**TOWN OF YARMOUTH**  
200 Main Street, Yarmouth, Maine 04096  
[www.yarmouth.me.us](http://www.yarmouth.me.us)

**Planning Board Report**  
**Hancock Lumber Showroom Addition, 258 Main Street**  
**Preliminary Plans for Building & Lot Plan, & Major Site Plan**  
**L & S Limited Liability Company, Applicant**  
**Map 37 Lot 19; CD4 Village Center**  
**Prepared by Erin Zwirko, Director of Planning and Development**  
**Report Date: May 19, 2022; Planning Board Date: May 25, 2022**

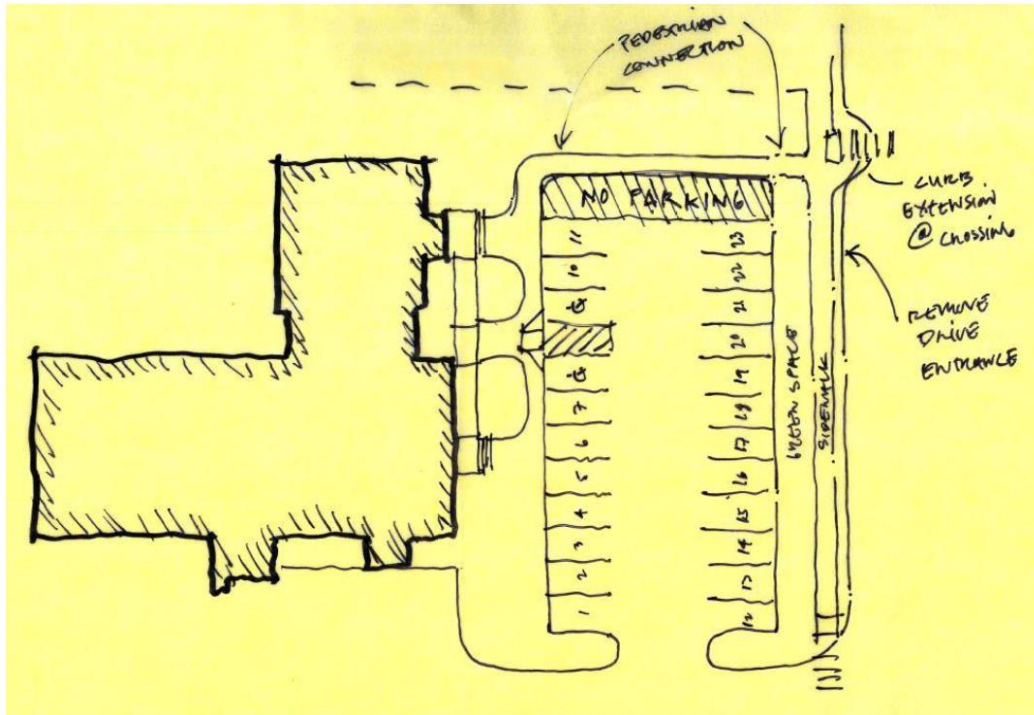
With the refined calculations, the amount of parking required is within the range allowed by the CBDC of a minimum of 30 spaces and a maximum of 60 spaces. The proposed 50 parking spaces are within the range by removing the parking located perpendicular to the westerly property line. One EV charger will be installed as will a bike rack. A waiver from the CBDC parking requirements is no longer necessary.

The question regarding the need for the second driveway was discussed previously at the April 13<sup>th</sup> Planning Board meeting. The Traffic Peer Reviewer also recommends that given the traffic volume levels the property does not need two driveways. He writes, *"Given the urban location and desire to improve access conditions, it is my recommendation that the westerly driveway be closed. The space could be used for landscaping or additional parking. This driveway is also located adjacent to a Main Street crosswalk and elimination will improve pedestrian safety."* The Traffic Peer Reviewer also recommends that a pedestrian facility should be provided between the Main Street sidewalk and the building entrance. The Traffic Peer Reviewer also questioned the purpose of the extended turnaround area as it seems excessively long.

In reviewing the updated site plan, the Code Enforcement Officer offered an alternative layout for the parking lot that would bring the proposed project closer to meeting the CBDC goals without forcing a layout of the site in order to meet the setback requirements of the CBDC. The alternative is presented in the illustration below, which nets additional parking spaces, eliminates the need for the turnaround, and provides the pedestrian facility from Main Street to the building entrances:

Finally, as noted by the Code Enforcement Officer, there is some discrepancy on the plan regarding the number of accessible parking spaces. Some plan sheets show 2 spaces while others show 3. This should be clarified, and the applicant should note that each accessible parking space must have an adjacent access aisle and at least one van accessible space must be provided.

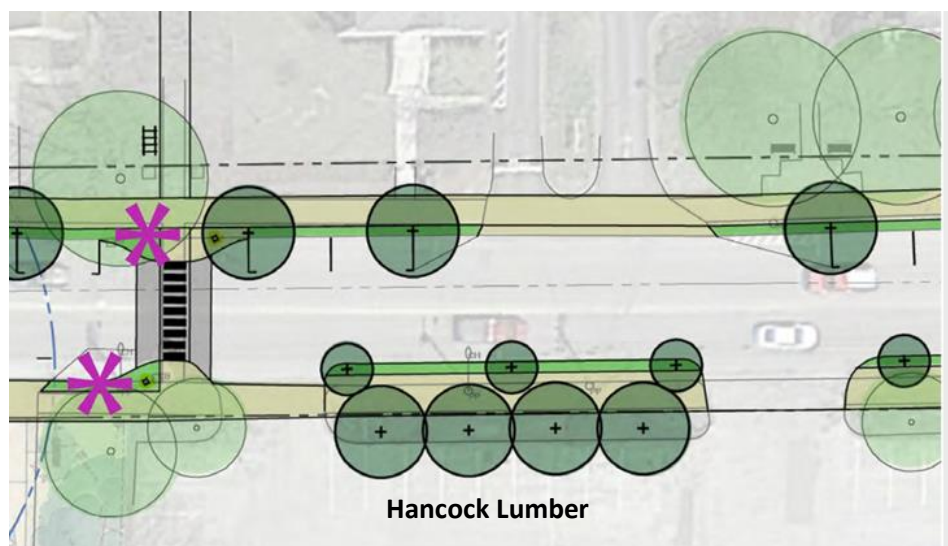
The site plan indicates that a maple tree behind the proposed addition will be protected. There are also other mature trees along the westerly property line and elsewhere on site that should be protected during construction. The construction plan indicates that this existing landscape will be located behind a construction fence.

A landscape plan was provided with a planting list. The landscape plan does not show that the maple tree behind the expanded building will remain, so the landscape plan may need to be cross referenced with the site plan more closely.

With the Main Street Streetscape improvements incorporated into the site plan along the Hancock Lumber frontage, the DPW Director notes that the sidewalk will impact the existing trees and plants. This existing landscaping should be removed, and planting that meet the requirements of the CBDC and reflect the streetscape plan should be replanted. Any new trees will need to be installed in structural soil that will provide strength for the sidewalk and the tree roots space to grow without impacting the sidewalk. A detail for structural soil planting needs to be provided. This provides an opportunity to remove the nuisance and invasive species in favor of native plantings.
